Wild Goose Storage, LLC
A Rockpoint Gas Storage Company
PO Box 8, 2780 West Liberty Road
Gridley, California 95948
T 530.846.7351
rockpointgs.com

In response to the CPUC – SED's June 26, 2017 closure letter, regarding the October, 2016, **General Order 112 Transmission Integrity Management Program (TIMP) Inspection of Wild Goose Gas Storage (WGS)**, attached please find an update addressing items that had been identified in the SED's report, related to the WGS 30" pipeline High Consequence Area (HCA).

Wild Goose Storage

HCA Analysis

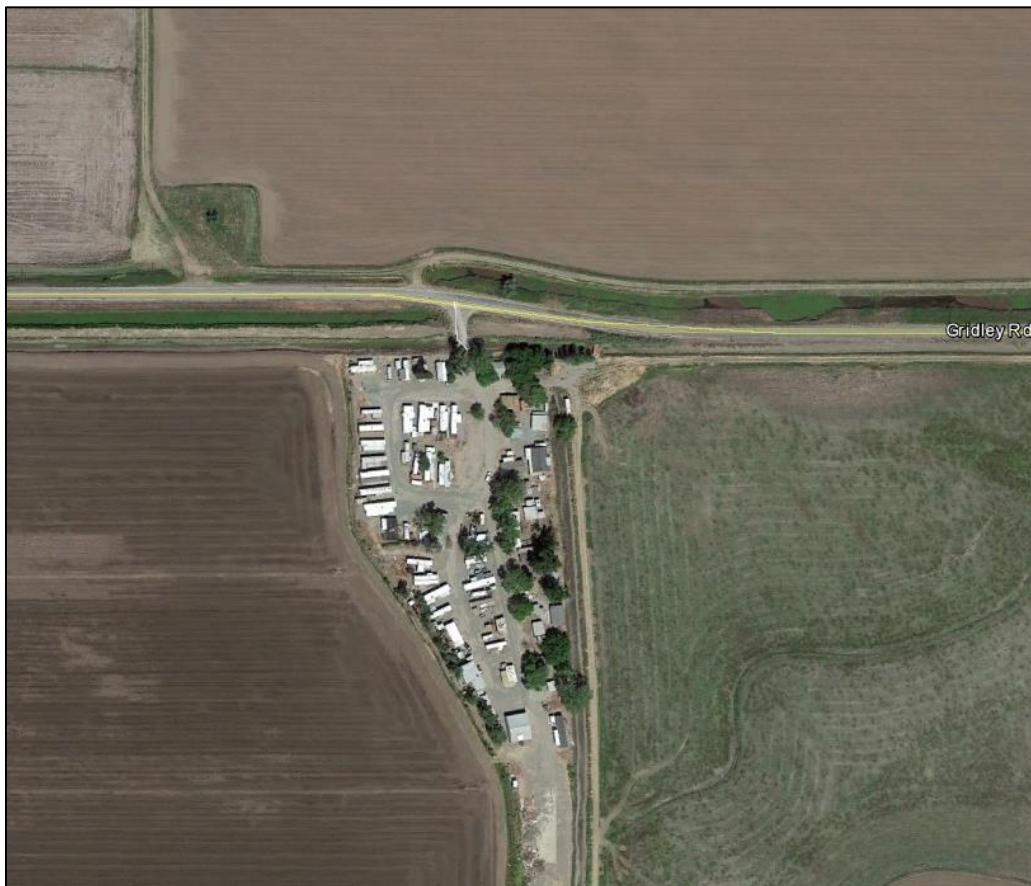
This item is related to item 4 (Question 5) above, which discussed the “System MAOP.” If the true extent of the HCA only encompasses Segment #68, then this will help define the true extent of the engineering stationing.

WGS’s response adequately addresses this concern. However, SED staff will also leave this item open pending WGS’s update to SED staff about the true engineering extent of the HCA.

As discussed in “WGS’s Response (Aug 4/17)” to item 4, an analysis was performed by GTS Engineering to confirm the HCA boundary. The assessment resolved that the HCA is between Station 978+51 to Station 1010+68. This was determined using a combination of information that’s explained in detail within the HCA Analysis report. Based on the analysis, the HCA encompasses a portion of pipeline Segment’s #67, #69

and all of Segment #68. The MDS will be updated following the annual WGS IMP review, which is scheduled for mid-August 2017. The revised HCA boundary does not impact the pipeline MAOP, which is 1,226 psig.
